Gas Membrane Verification Report

Verification Certificate

Lidl, Havant
Somborne Drive
Havant
PO9 5AN

GeoShield Verification Report 1

Verification Layout

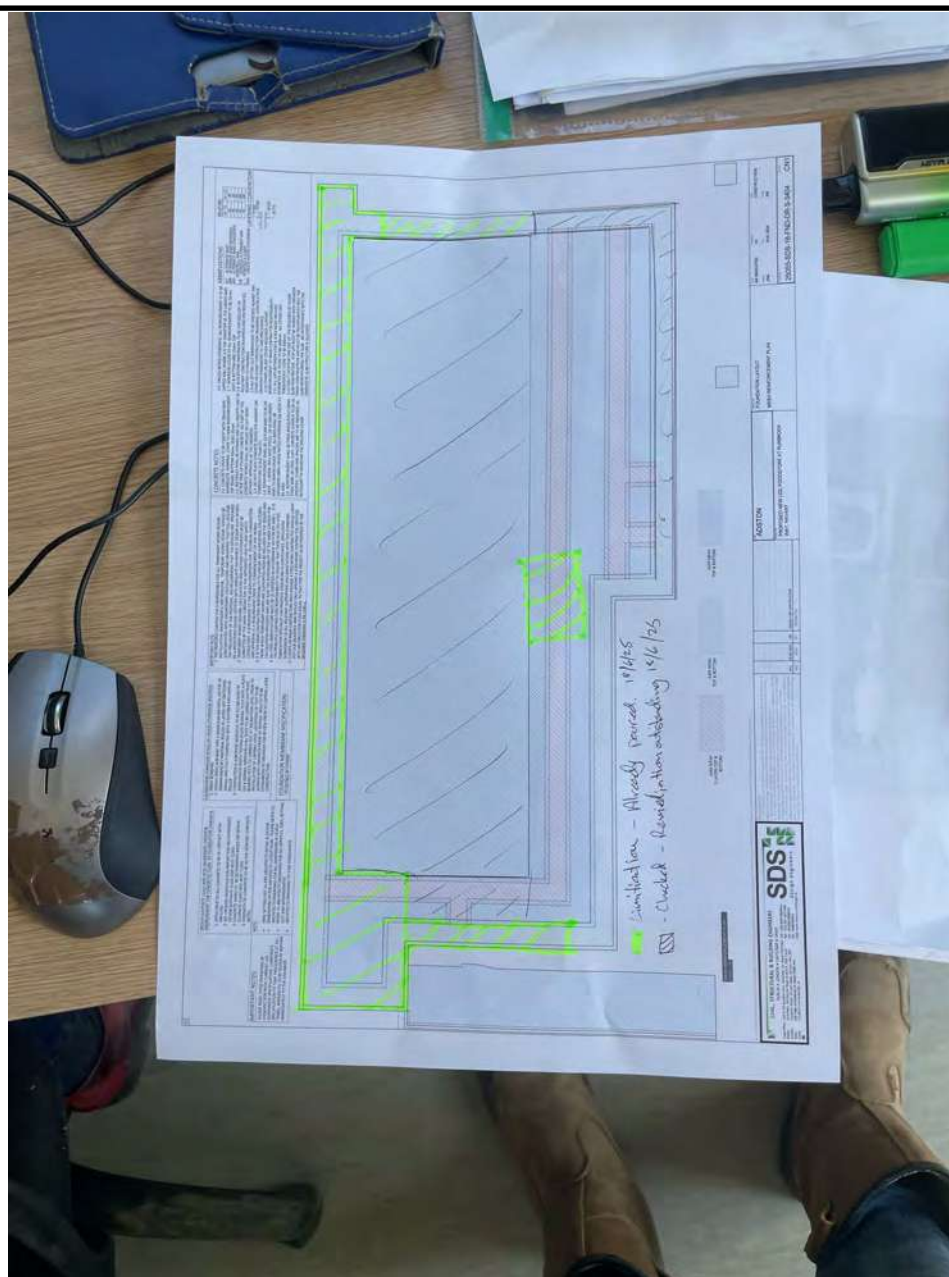
The photograph above shows a plan layout of the site. The area highlighted in black shows where the verification inspection took place on site today. However, the yellow highlighted area has already been poured.

As can be seen from the above image the areas of thickenings and approximately 30% of the perimeters have had concrete already poured. These have been shown as the highlighted yellow area on the layout drawing.

Verification Layout

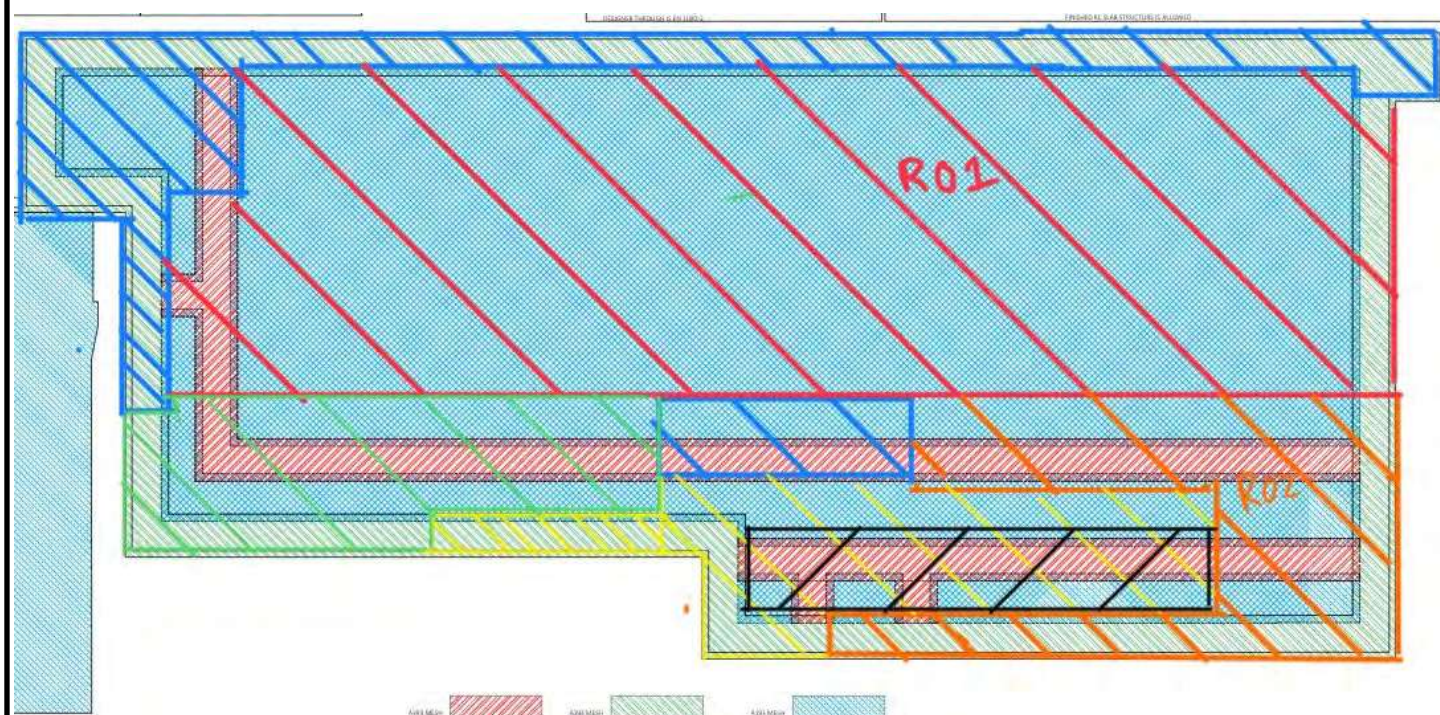
The photograph above shows a plan layout of the site. The area highlighted in yellow shows where the verification inspection took place on site today.

As can be seen from the above image there is an area outlined in black to the area inspected (yellow) which has been covered with insulation and steel reinforcement. Due to this being in place and unable to remove on site the client will need to provide photographic evidence of the membrane installation to this area.

Verification Layout

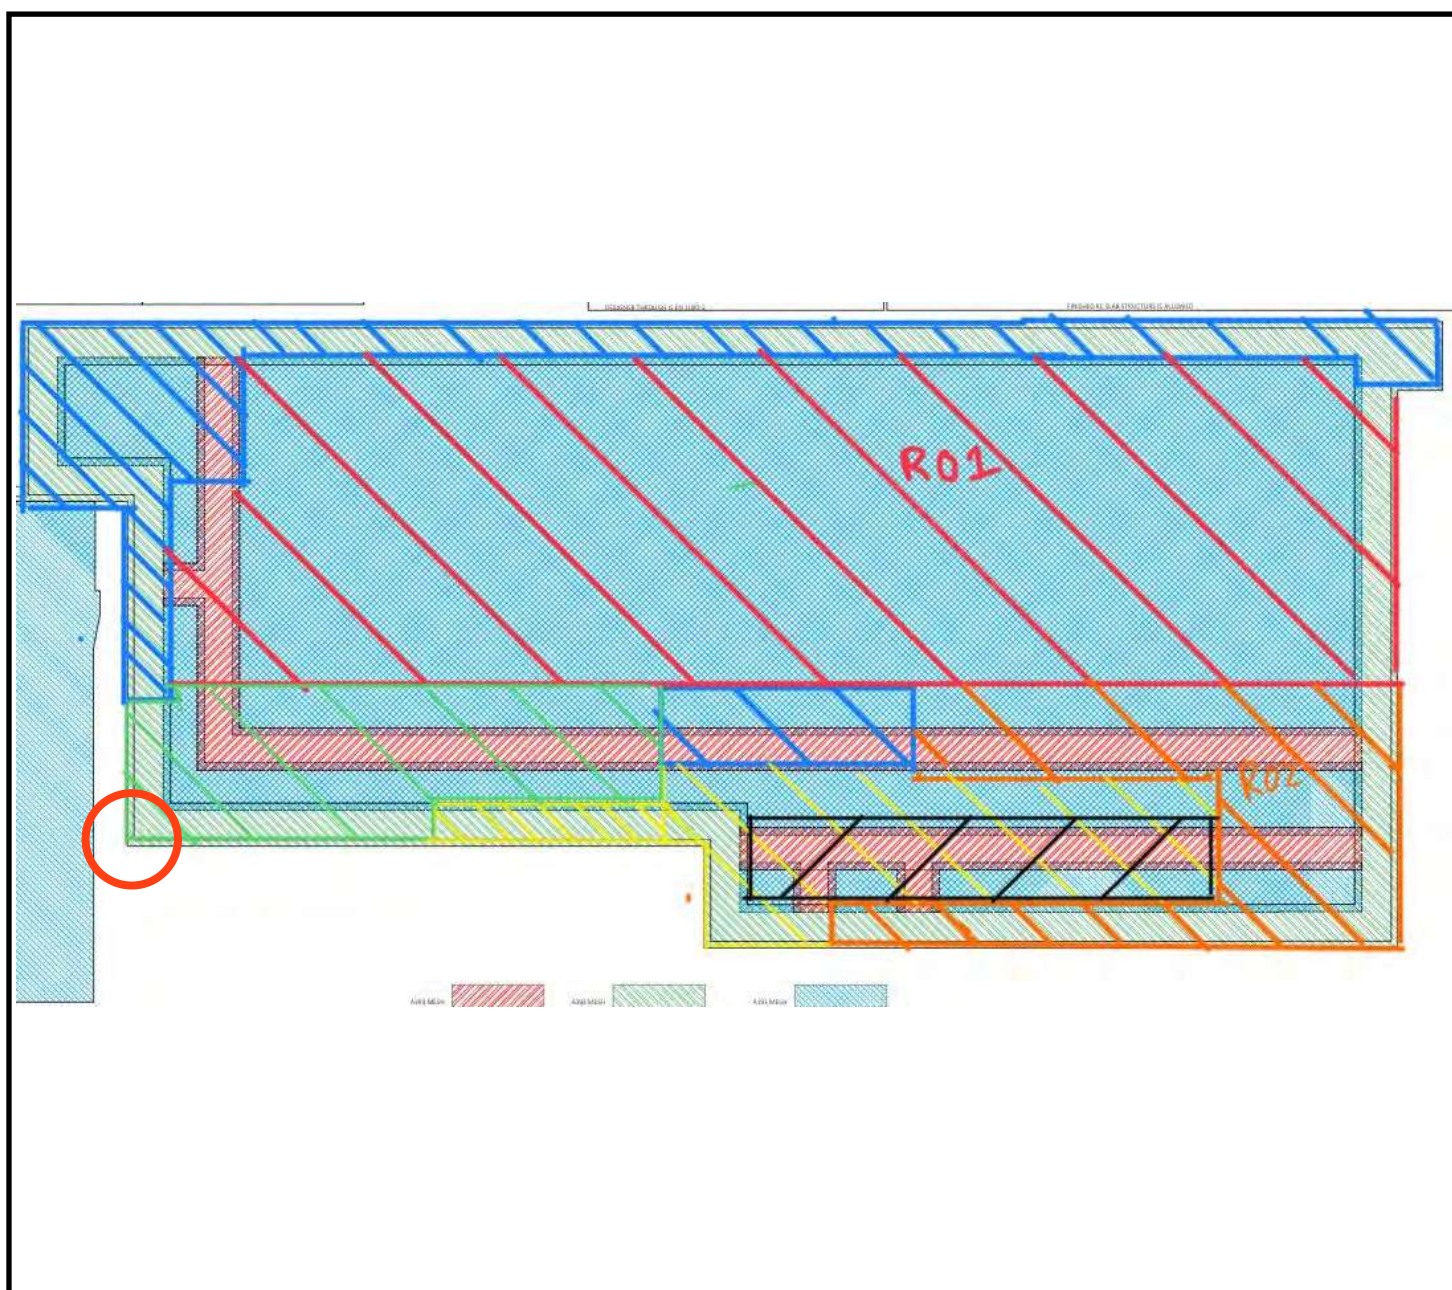
The photograph above shows a plan layout of the site. All areas bar the corner of the green section have now had photographic evidence provided for the outstanding remediations

Outstanding Remediation

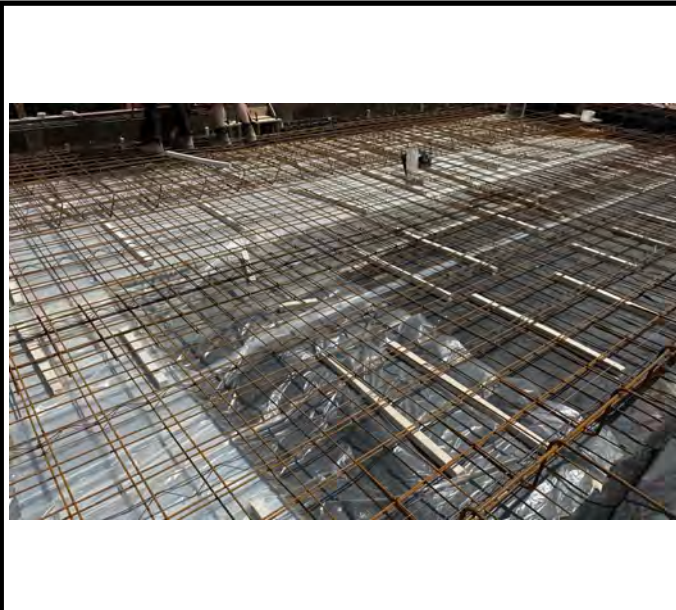
Corner of the green area that requires remediation due to steel beam no longer being extended.

The green section still requires a corner detail to be completed due to the concrete beam no longer being extended, once this is complete this section of the slab will then be signed off.

Verification Layout

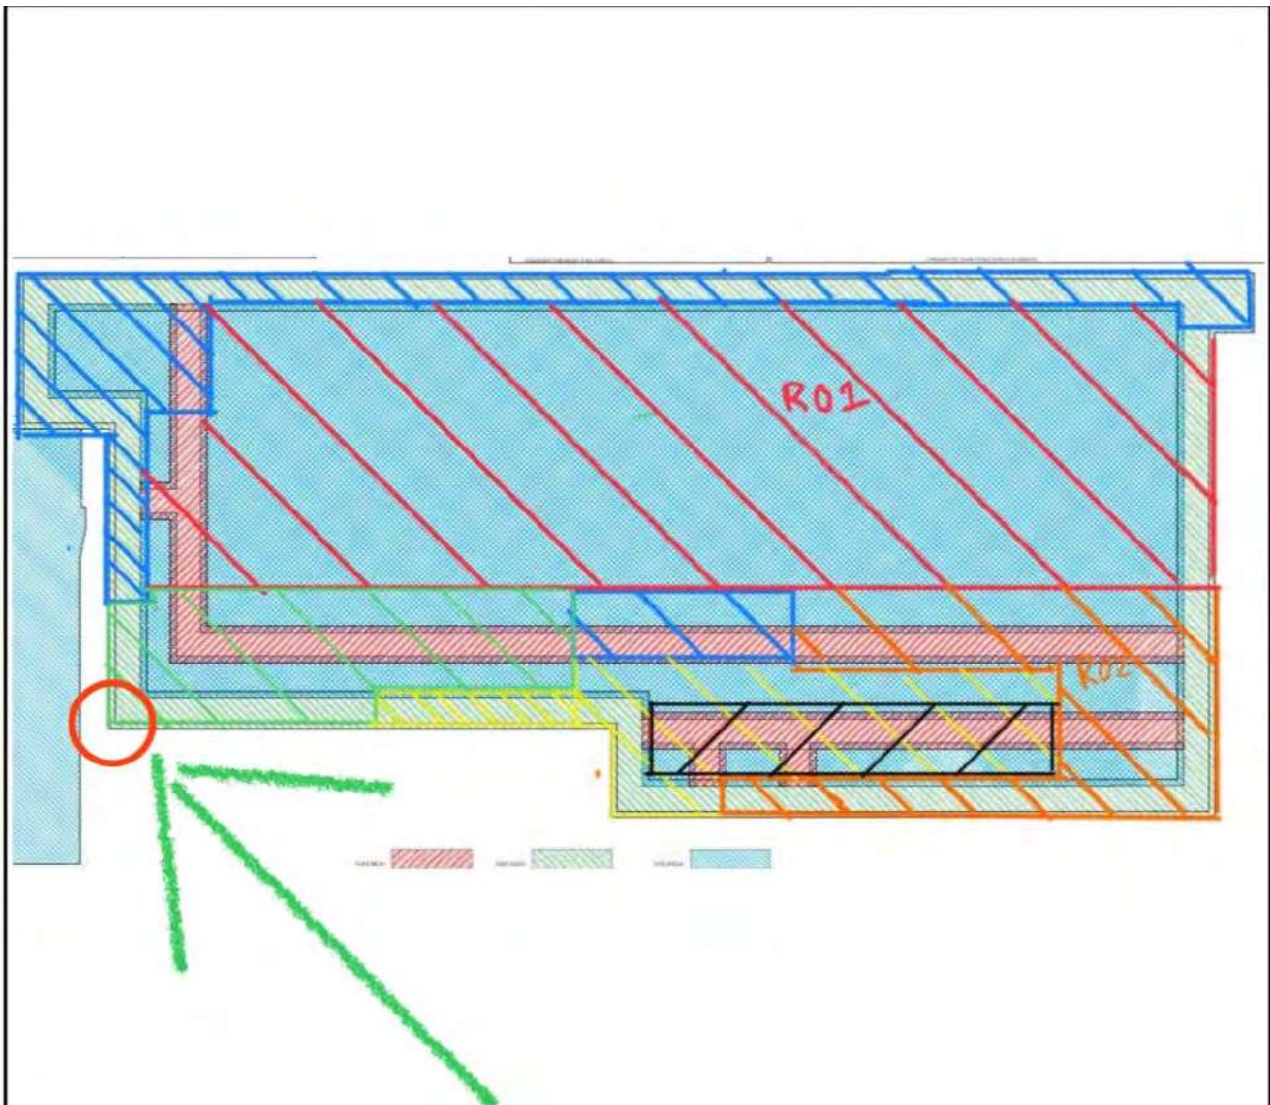
The photograph above shows a plan layout of the site. The area circled in red shows the corner in the green section where repair work was carried out and where the verification inspection took place.

VERIFICATION LAYOUT

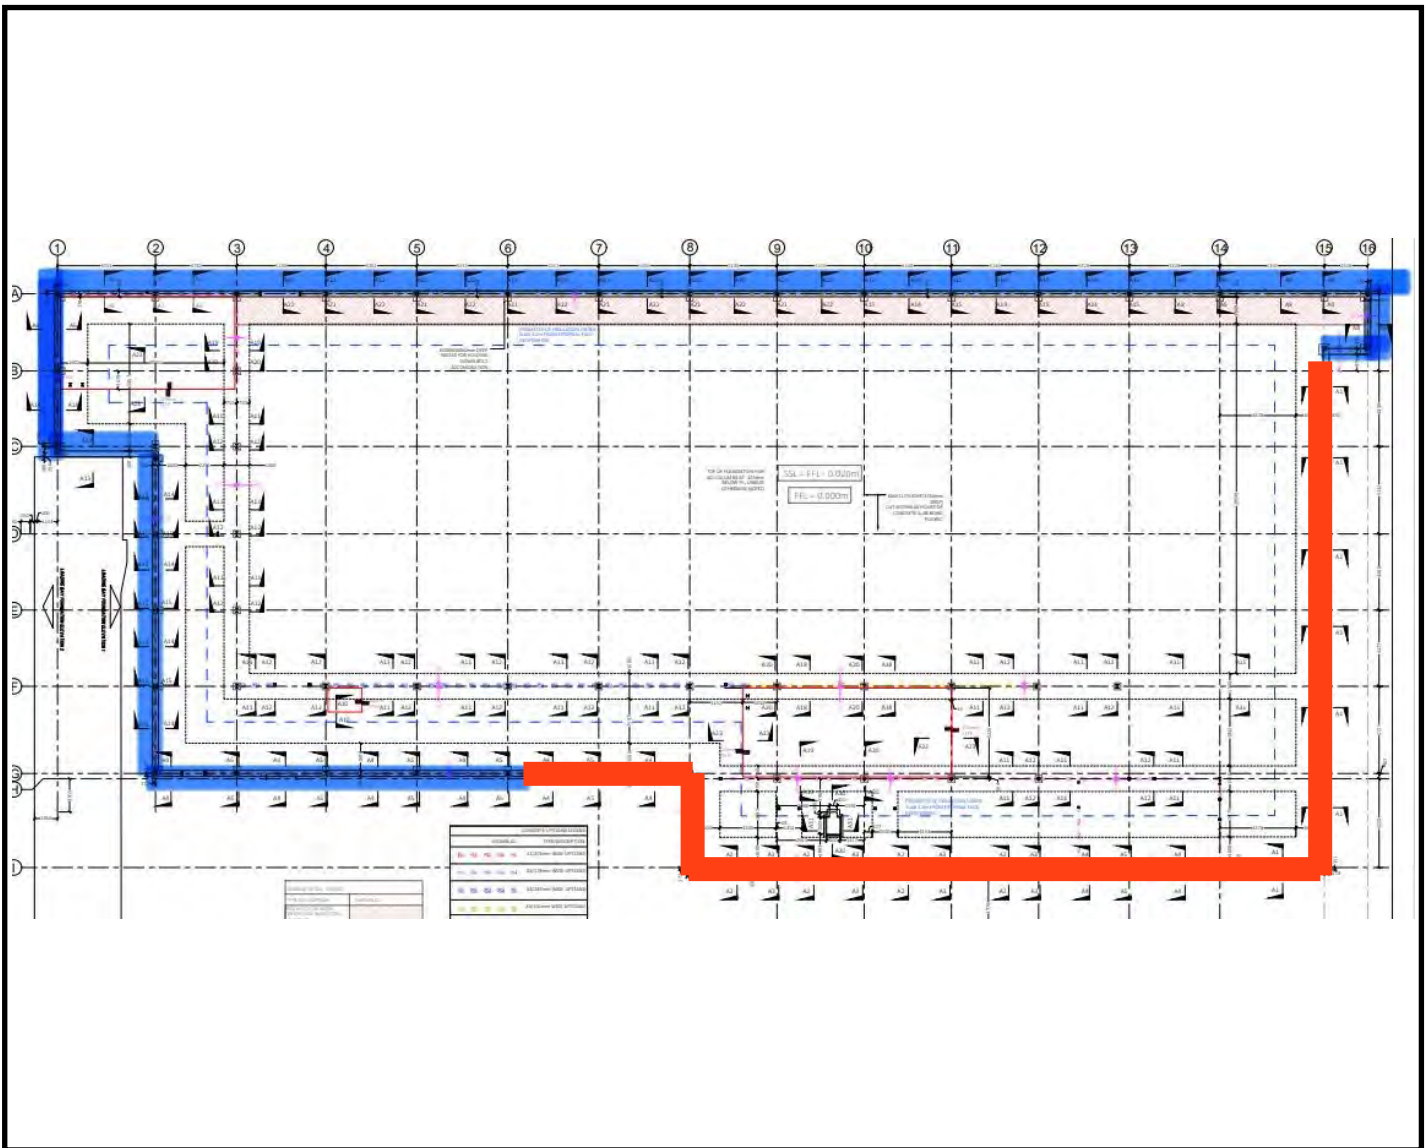
The photograph above shows a plan layout of the site. The areas highlighted in blue show all accessible areas around the perimeter. The areas highlighted in red show areas that were covered and therefore, could not be inspected. It has been recommended that these areas are uncovered in order that a full inspection can be conducted by GeoShield during the next verification visit.

ADDITIONAL PHOTOGRAPHS

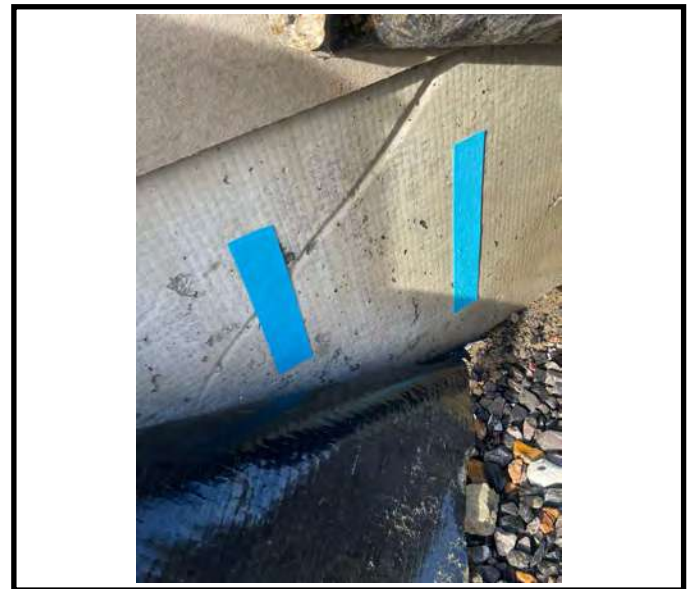
A pipe penetration incorrectly sealed with double sided butyl tape.

Holes and defects incorrectly sealed with double sided butyl tape.

VERIFICATION LAYOUT

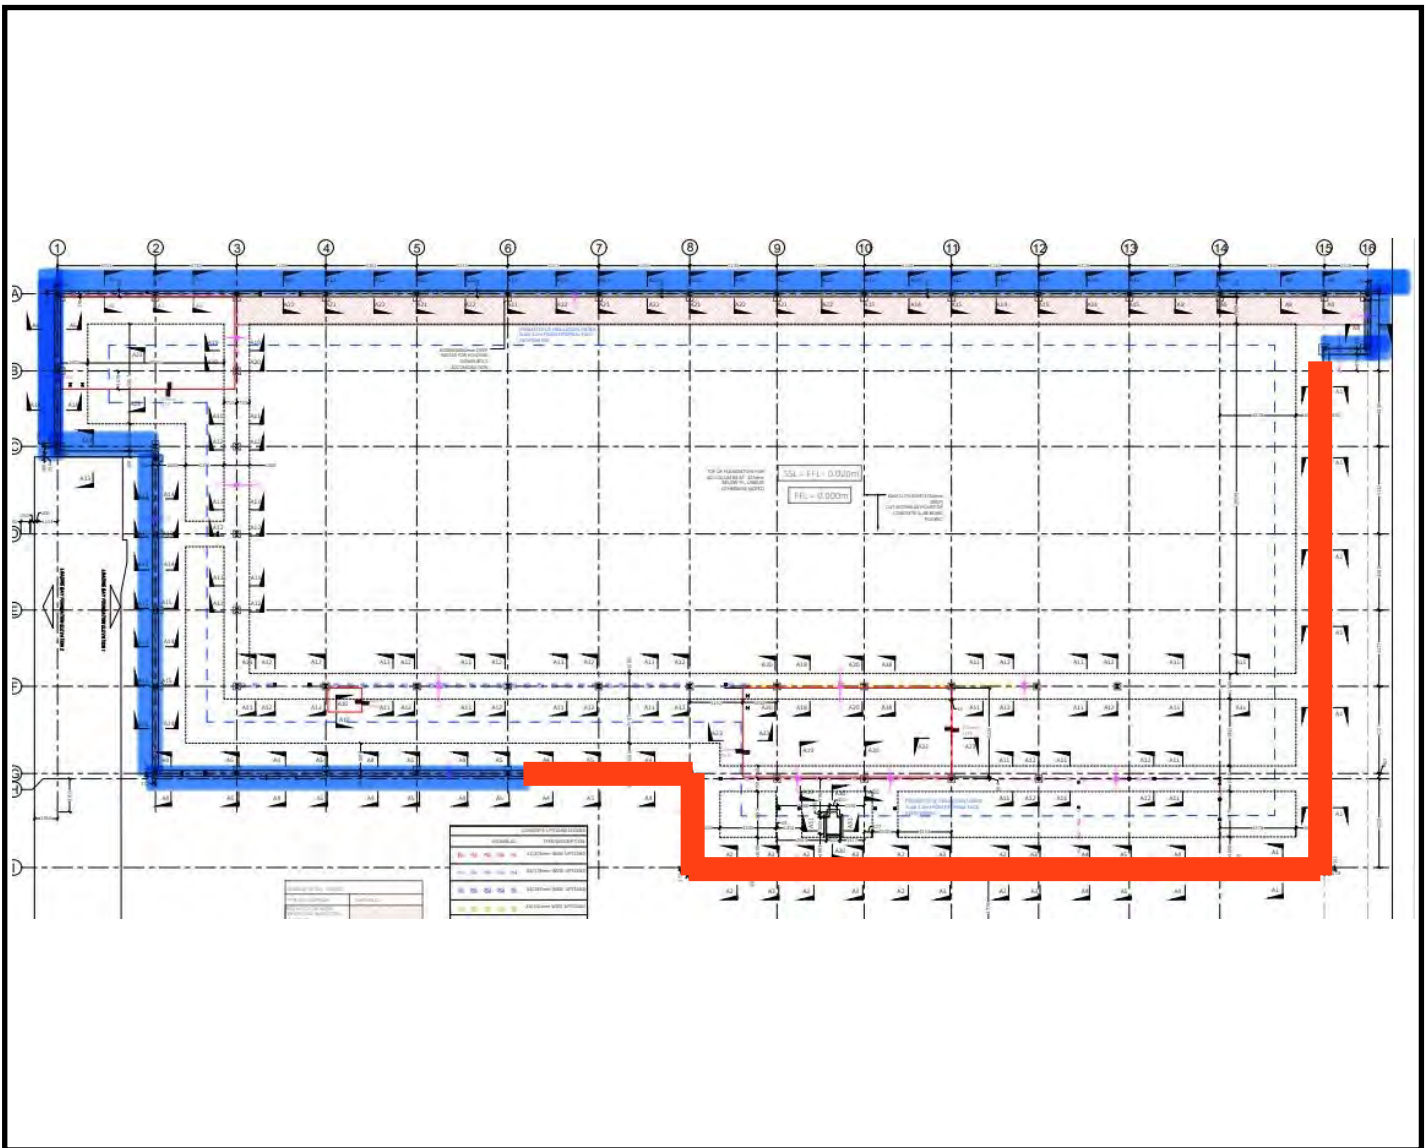
The photograph above shows a plan layout of the site. The areas highlighted in blue show all accessible areas around the perimeter. The areas highlighted in red show areas that were covered and therefore, could not be inspected. It has been recommended that these areas are uncovered in order that a full inspection can be conducted by GeoShield during the next verification visit.
